AGENDA
DESIGN COMMISSION
Community Room, 3rd Floor
Arlington Heights Village Hall, 33 S. Arlington Heights Rd.
Arlington Heights, IL 60005
May 13, 2025
6:30 PM

Design Commission
5/13/2025

Item: 832 N. Forrest Ave. / SF-Addition - DC25-029

Item: Slick City - 780 W. Dundee Rd. / Commercial - DC25-022

1/8"=1'-0"

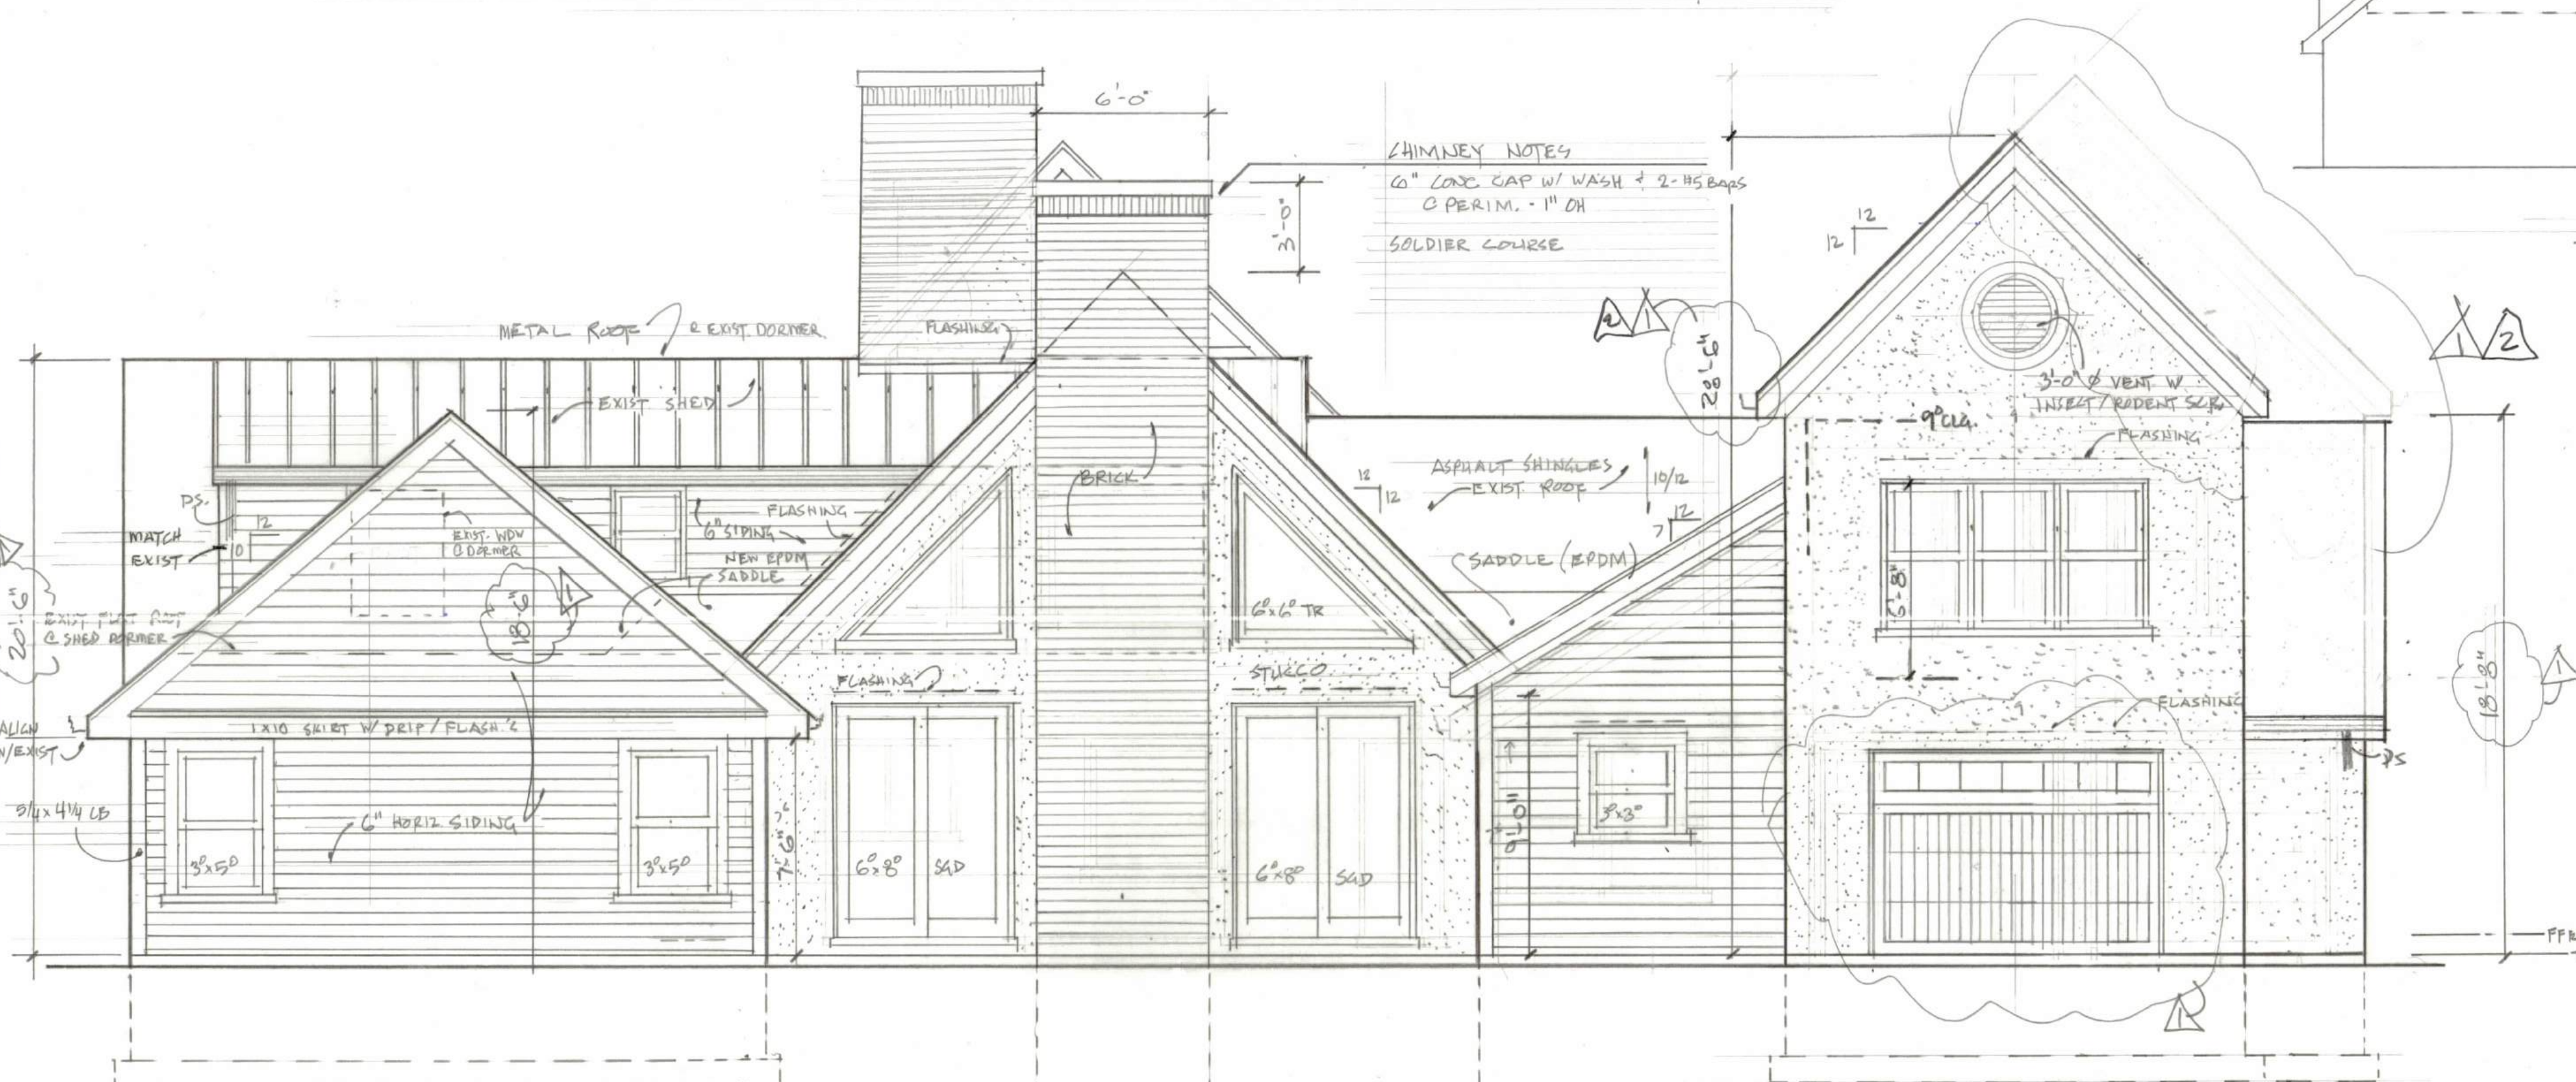
The subject property is on a street of large lots, where the minimum lots size is 20,000 sf and the minimum lot width is 100 feet. Many of the original homes on this street have either been expanded with additions or replaced with new larger two-story houses. The scale of the proposed expanded house fits comfortably on the large lot and with the surrounding context. However, the Design Commission should evaluate the massing of the proposed design which is unusual with an off-center dormer above the existing garage and a divided second floor. The proposed materials and colors for the house are also quite busy, with a combination of white horizontal siding, black vertical siding, white stucco, and buff limestone used on different parts of the house. The trim on the house is specified to be black, which is a bold look with white siding and white gutters. The Design Commission should evaluate the proposed massing and materials, which Staff recommends should be simplified for a more cohesive appearance.

1. A recommendation to simplify the proposed massing and materials/colors for a more cohesive appearance.
2. This review deals with architectural design only and should not be construed to be an approval of, or to have any other impact on, any other zoning and/or land use issues or decisions that stem from zoning, building, signage or any other reviews. In addition to the normal technical review, permit drawings will be reviewed for consistency with the Design Commission and any other Commission or Board approval conditions. It is the architect/homeowner/builder's responsibility to comply with the Design Commission approval and ensure that building permit plans comply with all zoning code, building permit and signage requirements.
3. Compliance with all applicable Federal, State, and Village codes, regulations and policies.

SHEET TITLE
EXTERIOR
ELEVATIONS

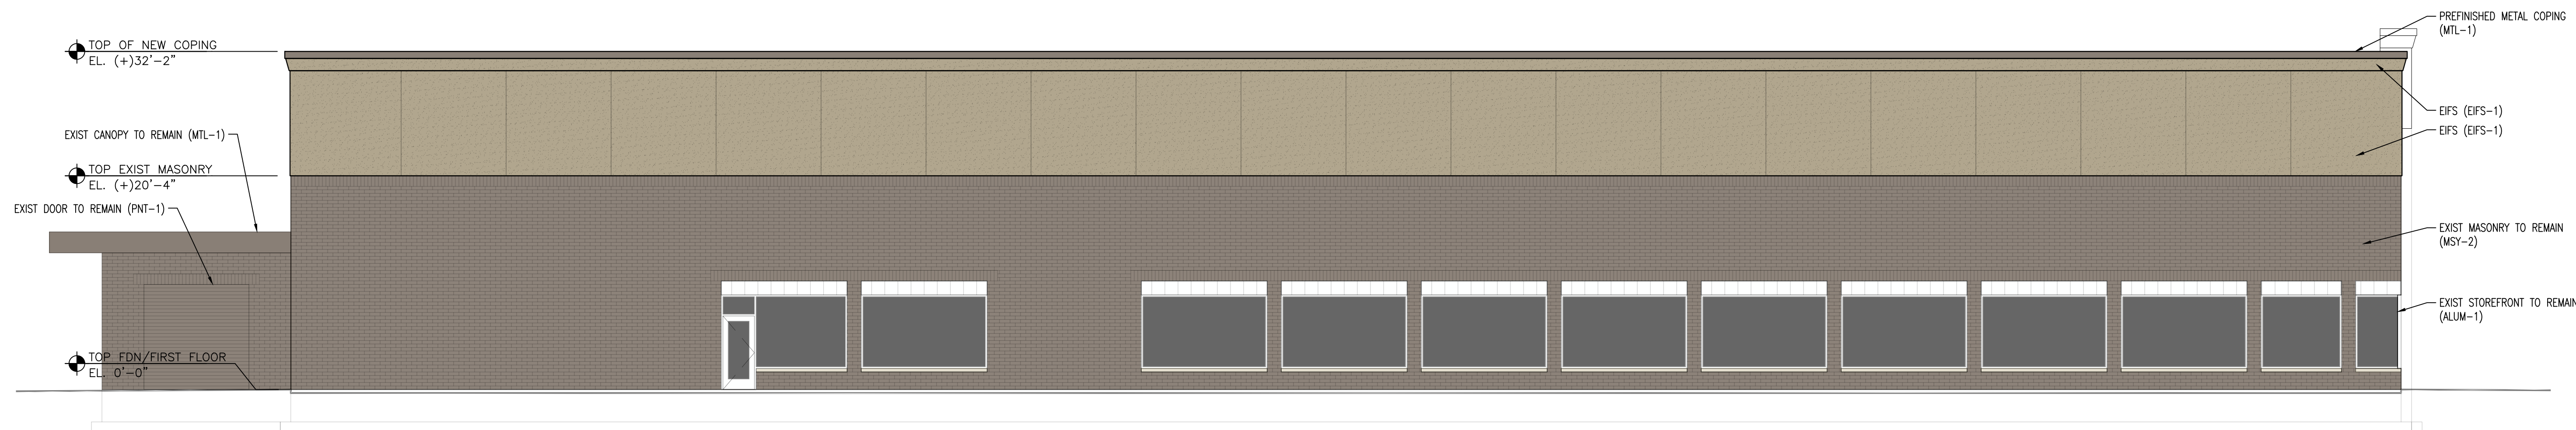
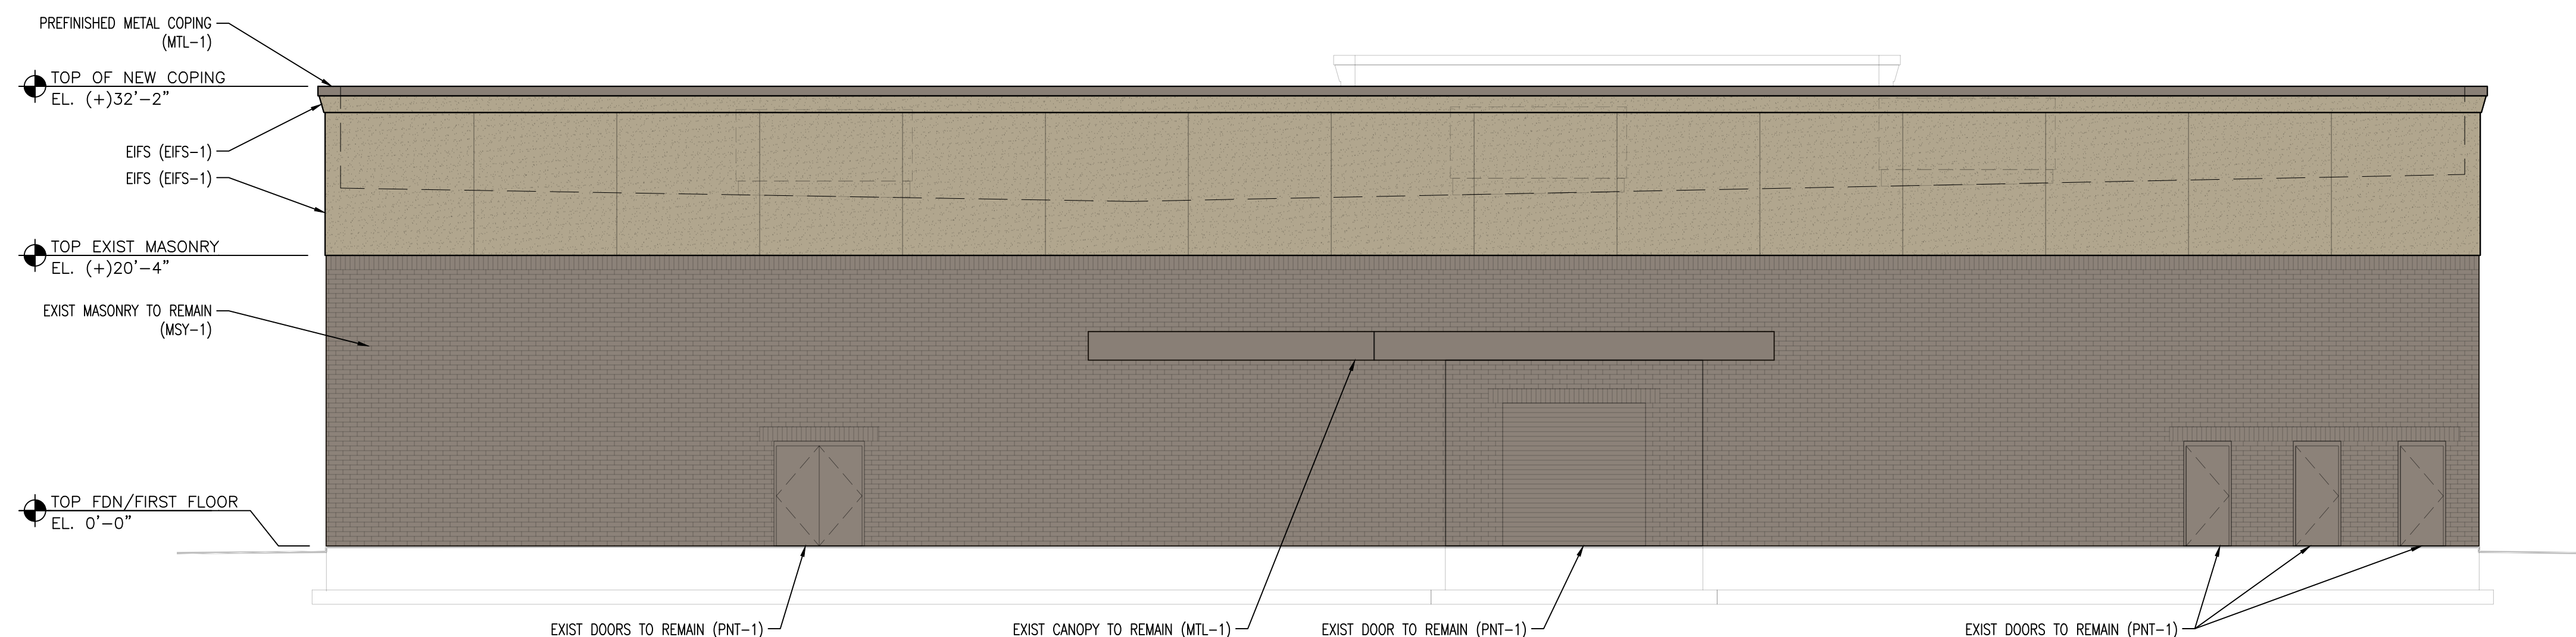
The wall height extension is proposed to be a tan EIFS on top of the existing brown brick on all four sides of the building. The main entrance wall is proposed to be painted blue, and will include a new black metal canopy to highlight the entry doors. Yellow fabric awnings are proposed above the storefront windows to further enhance the design. Overall, Staff feels that the appearance of the proposed wall extension fits well with the existing building, and the proposed colorful façade design is nicely done and appropriate to highlight this unique amusement type business.

All rooftop mechanical equipment is required to be screened from view. The new parapet walls are sufficiently tall to provide full screening of all rooftop equipment on all sides of the building.

It is recommended that the Design Commission **approve** the proposed architectural façade design for *Slick City* located at 780 W. Dundee Road. This recommendation is subject to compliance with the plans received 3/4/25, color rendering received 4-7-25, Design Commission recommendations, compliance with all applicable Federal, State, and Village codes regulations and policies, the issuance of all required permits, and the following:
